Campaign No. 2023060008, June 2023

SUBJECT: **Model C-Class (206 platform)**
Model Year 2023

Install Rivets on Cross-member above Rear Axle

Figure 1

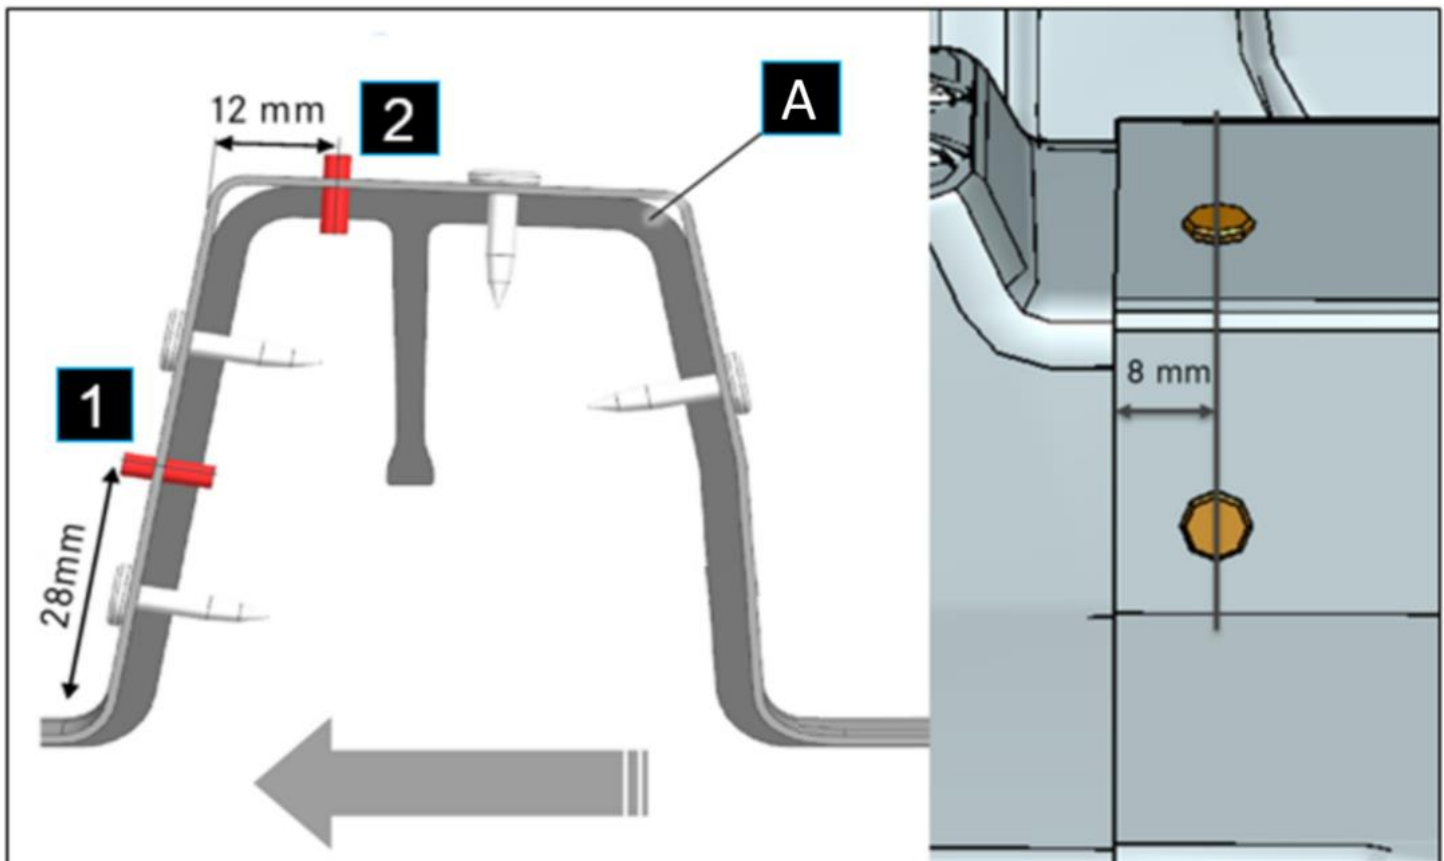
1. Remove rear seat cushion padding.
 - i For basic information, see: AR91.12-P-1022WT.
2. Remove seat backrest in rear passenger compartment completely.
 - i For basic information, see: AR91.12-P-1713WT (**except** code 287 (Through-loading feature)).
 - i For basic information, see: AR91.12-P-1723WT (**with** code 287 (Through-loading feature)).
3. Remove trunk lining.
 - i For basic information, see: AR68.30-P-4602WT (**except** code ME10 (Hybrid vehicle (plug-in, PHEV))).
 - i For basic information, see: AR68.80-P-6000WT (**with** code ME10 (Hybrid vehicle (plug-in, PHEV))).
4. Perform power disconnect for high-voltage on-board electrical system.
 - i For basic information, see: AR47.70-P-1010AMC (**with** code ME10 (Hybrid vehicle (plug-in, PHEV))).
5. Mark rivet holes on cross-member (**A**, Figure 1).
 - i Mark positions 1 and 2.

6. Drill 6.7 mm rivet holes and deburr.
7. Clean rivet holes and surrounding area.

Figure 2

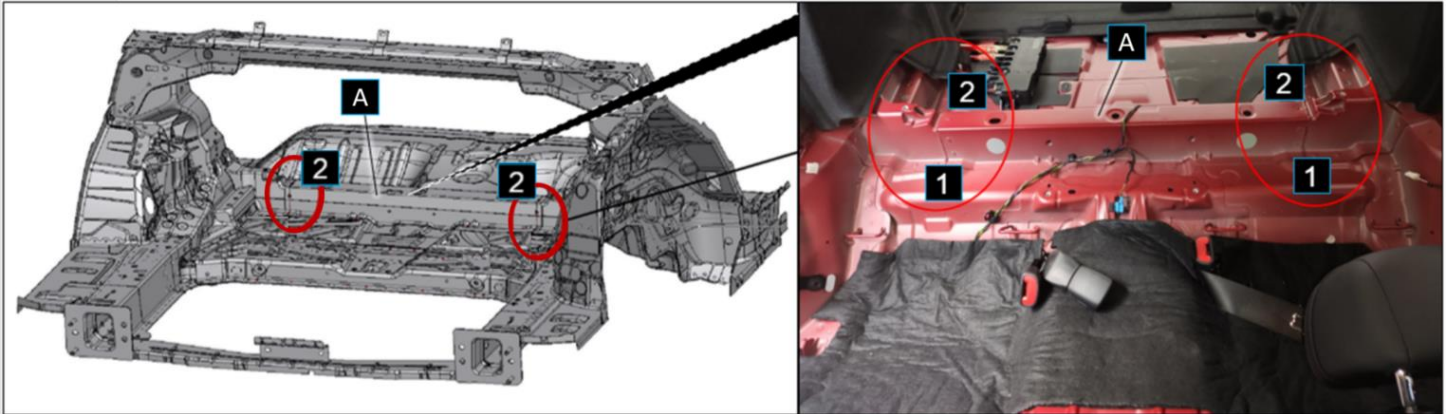
8. Rivet cross-member (**A, Figure 2**) with riveting machine at positions 1 and 2 (**Figure 2 and 3**).

- i Riveting tool with a pulling force greater than 19kN as per rivet specification is needed.
- i Dip each rivet into primer first.
 - a. Use 6.5 mm x 14.5 mm rivets (A 004 990 17 97) in positions 1.
 - b. Use 6.5 mm x 12.5 mm rivets (A 004 990 16 97) in positions 2.
